# BCA & DDA Capability Statement

Maitland Mental Health Rehabilitation Project  
51 Metford St, Metford, NSW 2323

NSW Health Infrastructure

04 October 2024

Figure 11: FRL of Walls to be Confirmed

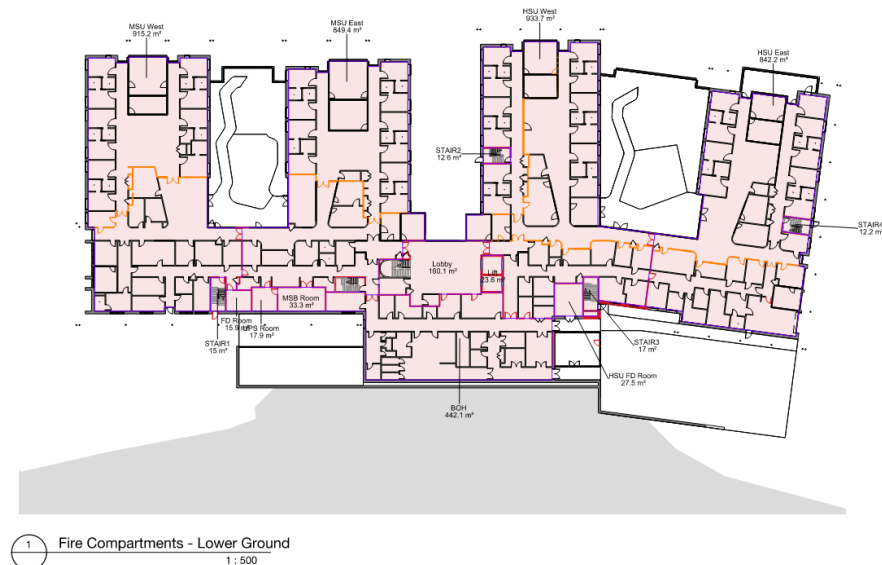
**Comment:** Having regards to the proposed compartmentation plan the following is noted:

- + A legend has not been provided nominating the FRL of the different colour coded walls – Note for the purpose of this assessment we have assumed that the highlighted walls have been assumed to be 120min combined fire and smoke walls.

- + All of the proposed fire walls are to be combined fire and smoke walls, Services consultant to ensure allowance is made for the protection of services and the like and the protection is in line with fire and smoke protection as required.

- + Provision of a standard detail showing how a compliant smoke reservoir of 400mm is being achieved above all compartment door sets throughout the building fire/smoke.

- + All separating floors throughout the building are to achieve an FRL of not less than 120min this is to be reflected in the compartmentation plan.
- + Smoke walls are to be documented as 120min fire walls for travel distance purposes in order to create Horizontal Exits and to future proof the works with respect of the Performance solution around bushfire compliance.

Figure 14: Fire Separated Lift Shafts

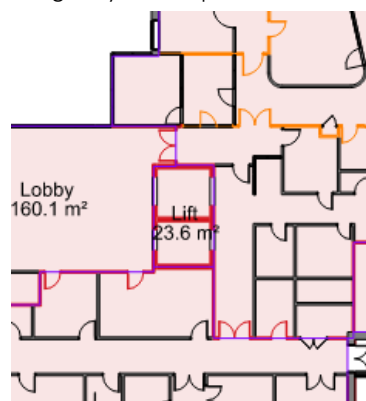
**Comment:** Compliance readily achieved; the lifts are shown to be fire separated as such compliance is readily achieved. Fire separation is also shown between the lifts and therefore separation in accordance with Emergency Lift requirements would readily be achieved.

Figure 15: Fire Separation of Equipment to be Confirmed

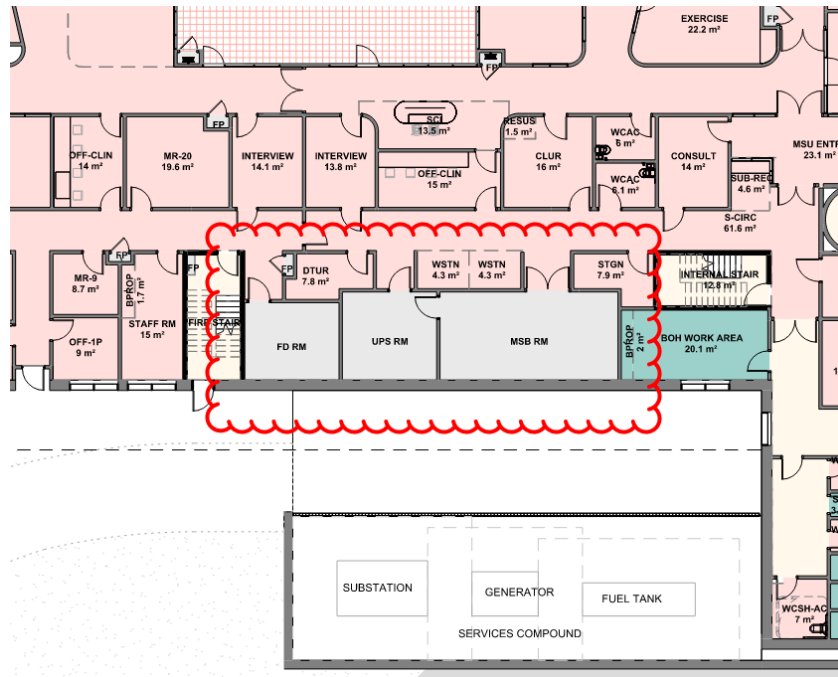
**Comment:** Compartmentation plans provided depict fire rating of switch and comms rooms as such compliance is readily achieved for these elements. This is to be monitored for compliance as the design developed in this regard.

The location of any other services or equipment requiring separation under this clause will need to be shown on the architectural documentation with the required 120min construction

Particular attention also needs to be paid to any distribution boards associated with a smoke hazard management system which will need to be fire separated under this clause. Mechanical consultant to review and ensure compliance with details being shown in the architectural documentation this is particularly relevant where the infrastructure is located in the proposed plant rooms.

Figure 16: Exposure between Fire Compartments – Lower Ground

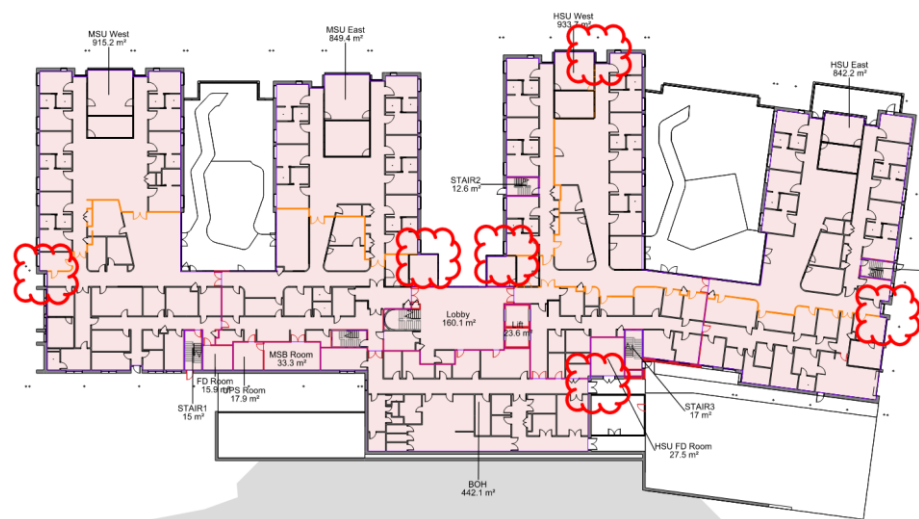
**Comment:** Exposure occurs between adjacent fire compartments in a number of locations as shown below. This is to be monitored for compliance as part of the design development and will be reassessed as required once the compartmentation strategy has been developed.

There would be an opportunity for the exposure between fire compartments to be addressed by way of a Fire Engineered Strategy where the design incorporates two-way protection. This would necessitate further plan amendments in this regard with all protection being shown on the architectural documentation in this regard.

Figure 19: FRL of Stair to be Confirmed

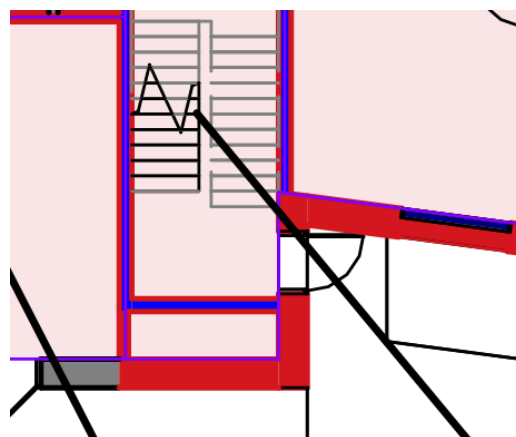
The external face of the below fire isolated stairway and the associated openings in the fire isolated stairway are required to be protected with fire rated construction equivalent of the stairway and openings in accordance with a method under C4D5 of the BCA. Updated architectural documentation to be provided in this regard.

*Figure 20: Confirm Egress via Internal Courtyards*

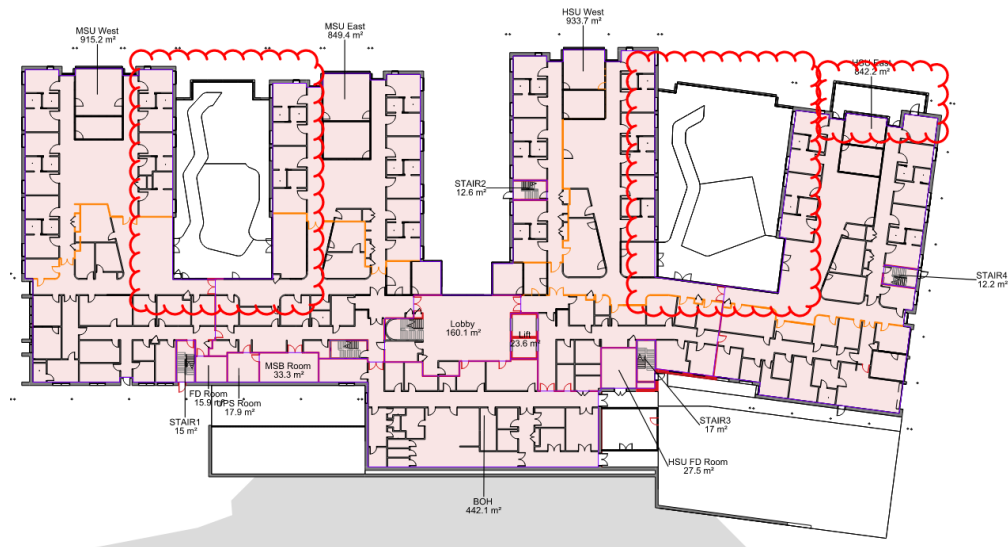
Egress from the larger internal courtyard areas on the lower ground floor will need to be confirmed, in the current design egress doors would need to be provided in the external fenced area in order to achieved acceptable travel distances. As an alternative the extent of landscaped area would need to be reduced in order to achieve acceptable travel distances back through the building.

Figure 21: Discharge within 6m of External Walls

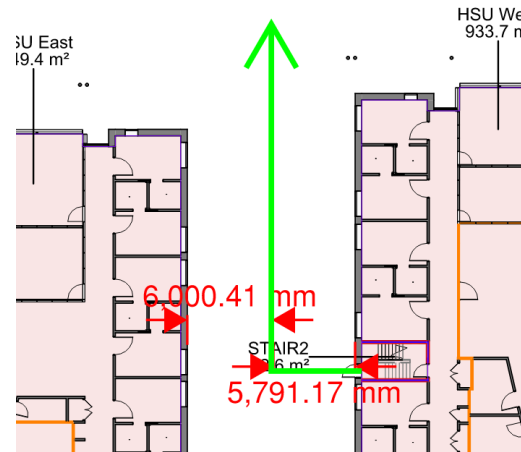
The discharge of the fire stair from the high support area into the internal courtyard shown below will need to be altered to ensure not less than 6m is maintained from the building line and a minimum 1m clear unobstructed width is maintained to the point at which open space is reached, otherwise all of the façade and other openings within 6m of the path of travel will need to be fire rated by 60min construction and have any openings protected in accordance with C4D5 of the BCA. Where this discharge location is to remain, it requires further coordination with the design team including the projects architect.

Figure 22: Discharge within 6m of External Walls

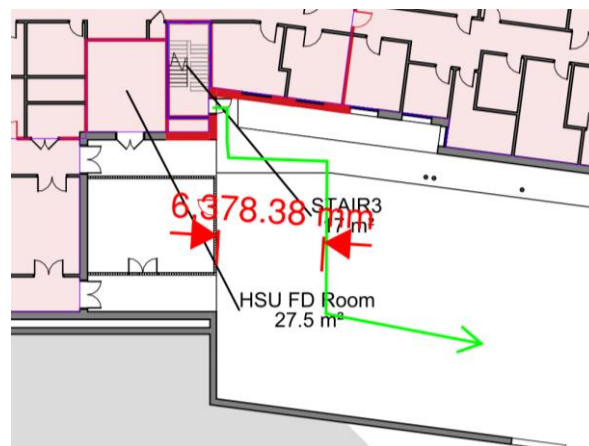
Where the paths of travel from the fire isolated exit provides the occupants with an opportunity to travel in opposite directions at the point of discharge then there would be an opportunity for the exposure to the external wall to be addressed under the Fire Engineered strategy typical example below.

Figure 23: Path of Egress from the Building to be Confirmed

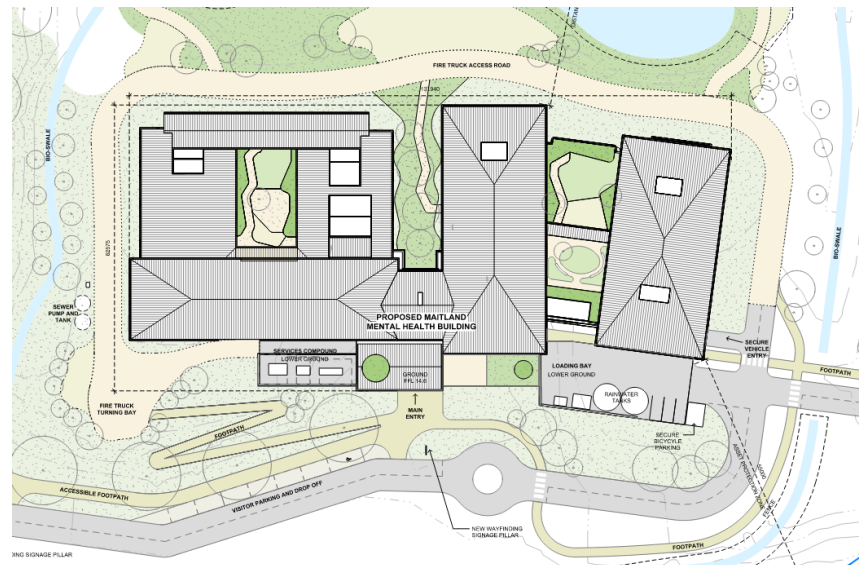
**Comment:** Location of and characteristics of path of travel from the building to the adjoining public road is still to be finalised to ensure compliance with the requirements of this clause further coordination is required between the design team including the project architect, landscape architect.

All of the proposed egress paths from the building will need to be provided with a compliant path of travel as required above. The architectural design is to identify all gradients and crossfalls proposed which will need to be provided for review and comment.

Where the design proposes stairways between the discharge points of the building and the adjoining public road this is to be documented as a fire engineered strategy by the projects Fire Safety Engineer.

*Figure 24: Internal Hydrants to be Accommodated in FIS*

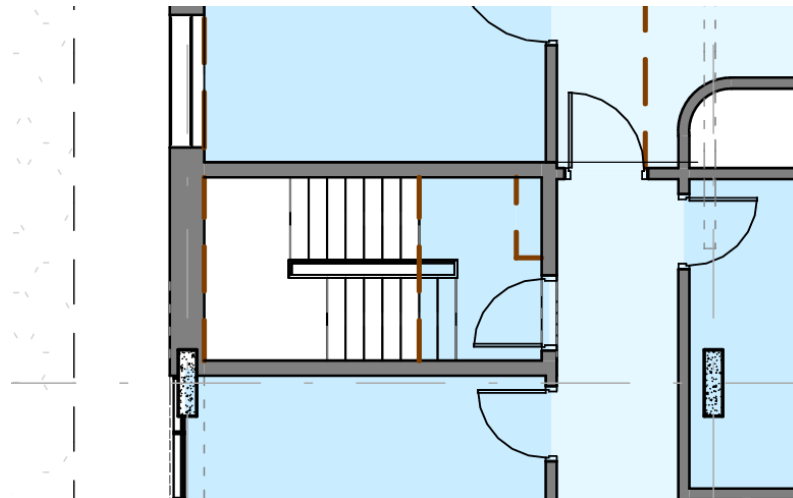
**Comment:** Note- stretcher diagrams provided for all the fire isolated stairs, this is to be coordinated to ensure any fire services located within the stair are not obstructed, which is of particular note

where a combined hydrant sprinkler system is proposed in the building. Early coordination is required to ensure sufficient spatial allowance to the proposed stair shafts noting the design does not appear as though compliance will be achieved.

Figure 32: Sliding Doors in Patient Care Areas

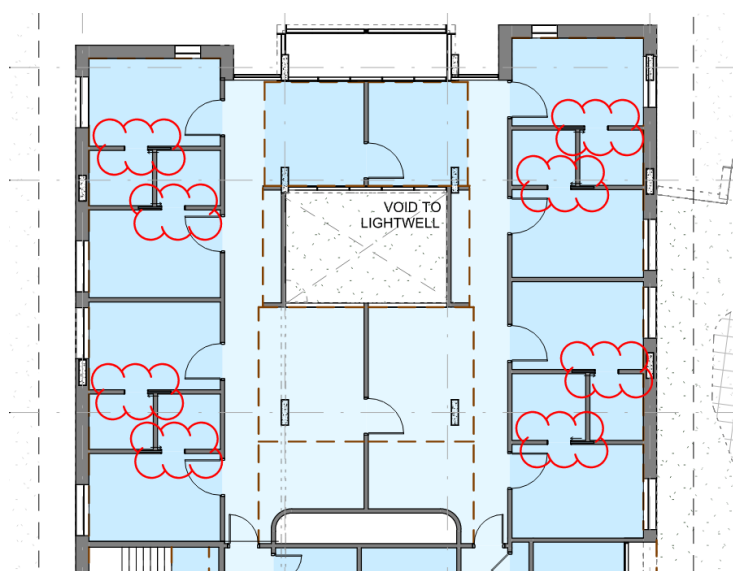
**Comment:** The proposed sliding doors in the patient care areas will need to be addressed in the Fire Engineering strategy.

Figure 33: Door Circulation and Landing Non-compliance

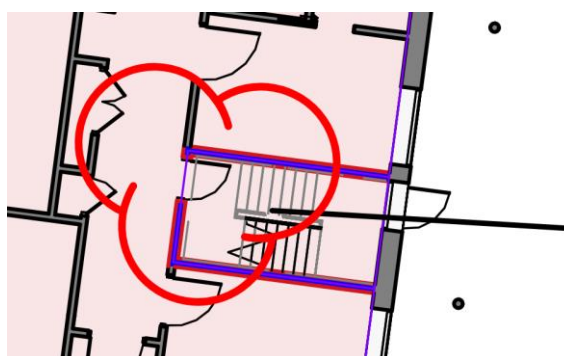
Spatially the size of the proposed stairway shafts and the door location opening is to be reviewed by the project architect the current design would not comply spatially with respect of the door swing and size of landings as it encroaches by more than 500mm. Updated documentation is to be provided to BM+G demonstrating compliance in this regard.

Figure 34

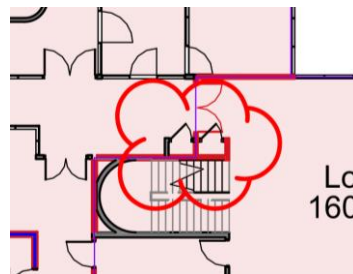
The location of any FHR cupboard, EDB/Comms cupboard doors are to be positioned so that when opened they do not encroach on the adjacent compartment doors and or doors located on the path of travel. This will be subject to further review as part of the design finalization indicative areas of concern are as shown below.

Figure 38: Non-compliant Door Circulation

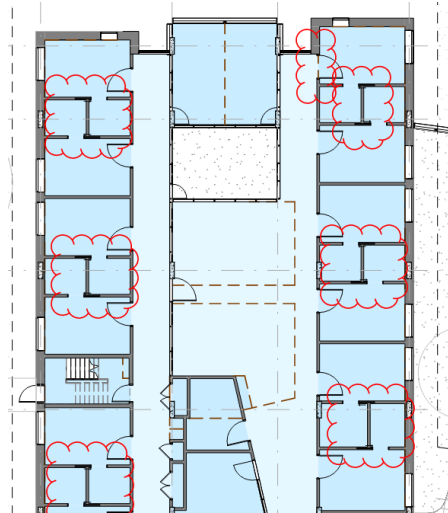
**Comment:** A performance solution is required to address noncompliant circulation space to a number of patient areas including ward areas and associated ensuites. Typical example shown below.

Figure 39: Access from Site Boundary to be Confirmed

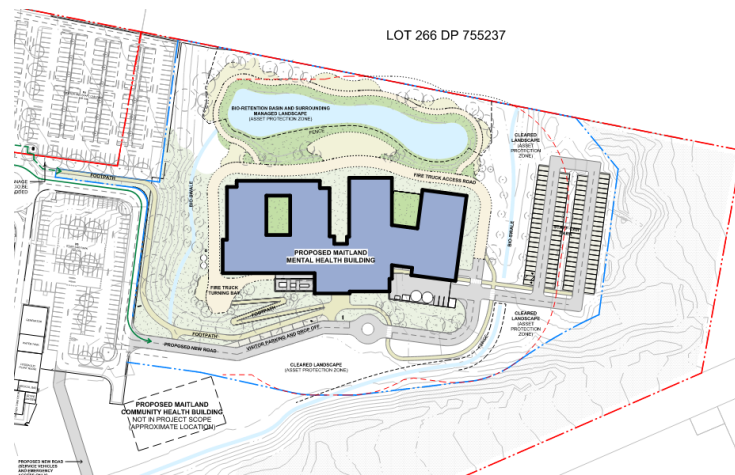
**Comment:** The following is noted having regard to the requirements of this clause.

dedicated accessible car parking bays being provided within proximity of the proposed building.

- The design does not show an accessible path of travel being provided between the existing hospital and proposed mental health facility – This is to be subject to further review as part of the design finalisation however there would be an ability for the omission of an accessible path of travel being rationalised under a Performance Solution.
- The location and number of accessible car parking spaces will need to be shown on the architectural documentation and submitted for review and assessment. The design is to incorporate an accessible path of travel from the designated accessible carparking bays to the subject building. The location of the accessible bays are recommended to be positioned within close proximity to the building entrance.

Figure 67

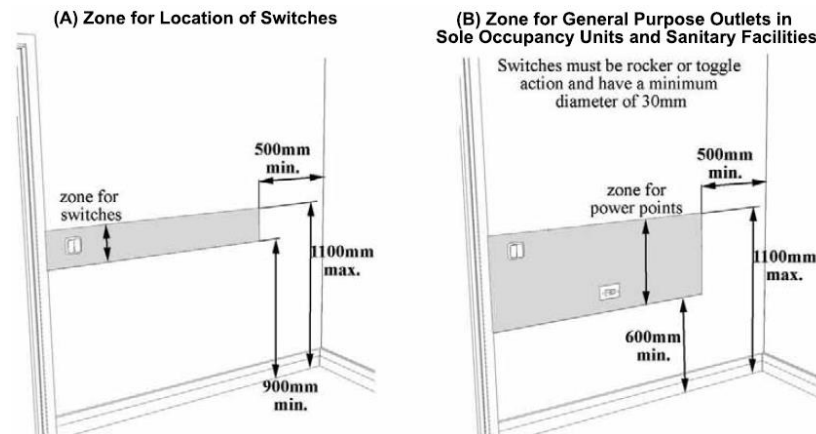
**Comment:** A number of doors do not achieve 1450mm clear width in between successive doorways require design development by way of altering direction of door swing or relocating door to different position within the wall. Typical doors below, rectify in all areas where this occurs.
